Applicability of Pipelocks as a Remedy for Intergranular Stress Corrosion Cracking in BWRs

ATTACHMENT 4

REQUEST FOR ADDITIONAL INFORMATION

Quad Cities Unit 1
Sustained Stresses at IGSCC
Susceptible Weld Locations

Figure 1
QUAD CITIES UNIT 1
FLAWED WELD LOCATIONS
REACTOR RECIRCULATION SYSTEM LOOP "A"

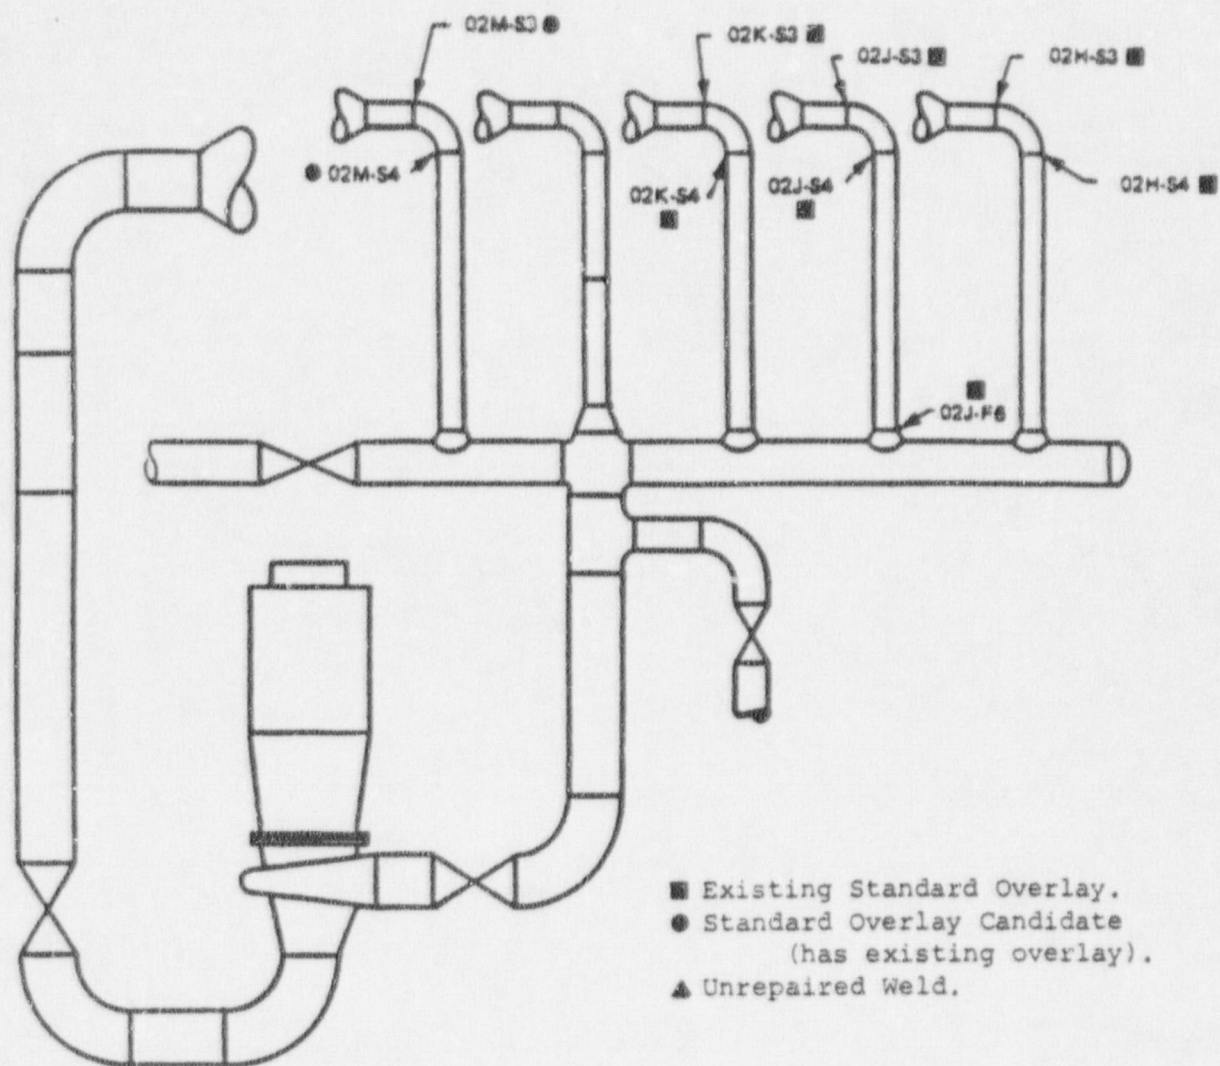
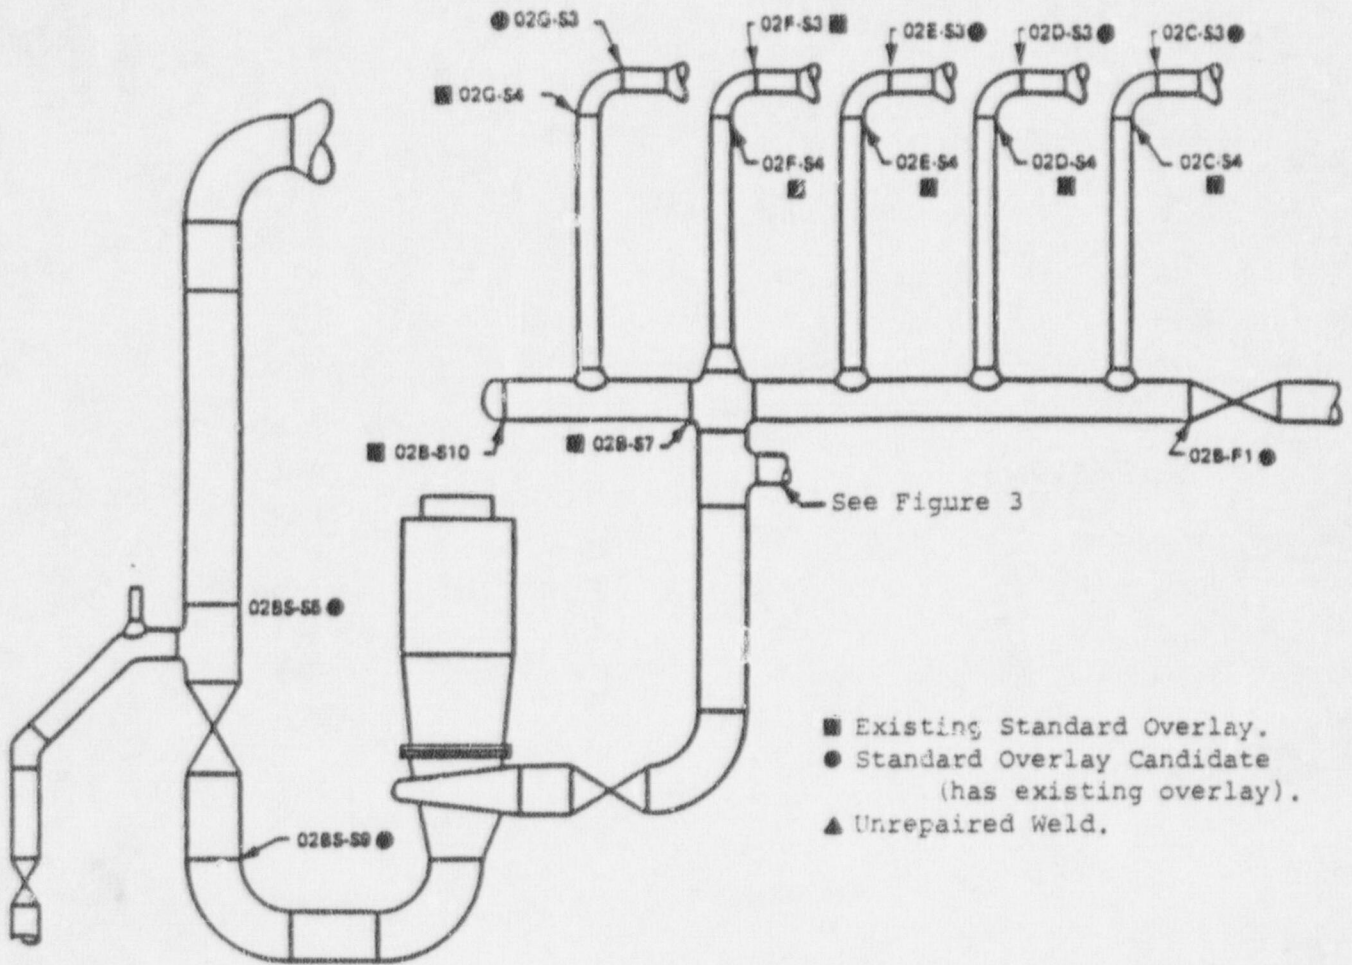
What is the affect of shrinkage caused by application of weld overlays on total applied stress in the piping systems?

During application of weld overlays, axial shrinkage of the pipe occurs. This shrinkage can change (increase or decrease) the total applied stresses in the piping system. These shrinkage induced stresses are usually very small when compared to the stress resulting from internal pressure, dead weight and thermal expansion. Shrinkage stresses resulting from weld overlays have always been considered during design of weld overlays. Results of these evaluations have been included in our design reports to the NRC concerning repair of IGSCC flaws. The concerns raised by NRR technical reviewers are related to the effectiveness of Stress Improvements (SI). Section 4.5 of NUREG-0313, Revision 2 states that mitigation by SI is not recommended for weldments with service stresses over $1.0 S_m$, cracks deeper than 30% of the wall, circumferential cracking longer than 10% of the circumference, or axial cracks of any extent.

Attachment 4 is a summary of sustained stresses at each weldment, including shrinkage induced stresses. All weld locations in IGSCC-susceptible systems have sustained stresses less than $1.0 S_m$, except one weld in the RHR Loop A (10AD-F1), one weld in the RHR Loop B (10BD-F1), one weld in the Shutdown Cooling System (10S-F1) and six welds on the recirculation system (02D-F2, 02G-F2, 02J-F2, 02L-F2, 02L-S3, and 02M-F2). Of these, 02L-F2 has sustained stress greater than $1.5 S_m$.

The recirculation system has been evaluated from a weld overlay shrinkage standpoint to determine ways of reducing the shrinkage stresses. As a result of this evaluation, one weld overlay will be applied on an unflawed weld (02L-S4) during the upcoming outage to reduce the sustained stress at 02L-F2 below $1.5 S_m$.

Welds contained in this evaluation are those contained in the suction and discharge lines, the risers and all the N1 and N2 nozzle-to-safe end welds. Excluded in the evaluation are all the saddle welds which are assumed to be solution heat treated and therefore are Category A weldments under NUREG-0313. Most welds in this system have received SI treatment. A total of twenty-four (24) flawed welds in this system have been repaired with weld overlays. The locations of these overlays are shown in Figures 1 and 2.

These overlays have introduced shrinkage stress that contribute to the total sustained stress at unrepaired weld locations. Sustained stress for welds in this system therefore consist of internal pressure, deadweight, thermal expansion and weld overlay shrinkage stresses. The sustained stresses calculated for the

various weld locations are shown in Table 1. It can be seen from this table that six (6) welds have sustained stress greater than $1.0 S_m$. These are welds 02D-F2, 02G-F2, 02J-F2, 02L-F2, 02L-S3, and 02M-F2. Of these only 02L-F2 has sustained stress greater than $1.5 S_m$. Weld overlay shrinkage stresses contribute significantly to the sustained stresses of these weld locations. Weld overlay repairs will be performed on several welds of the recirculation system during the upcoming outage. These repairs could introduce additional shrinkage in the system which could significantly change the shrinkage stresses at the various weld locations which could in turn change the sustained stresses. The magnitude of the shrinkage stresses is affected by the distribution of weld overlay repairs in the system. Non-uniform distribution of those repairs in the system has the potential of introducing significant stresses. Therefore weld overlay repairs are being applied at unflawed locations to provide uniform distribution of weld overlays and reduce the shrinkage stresses.
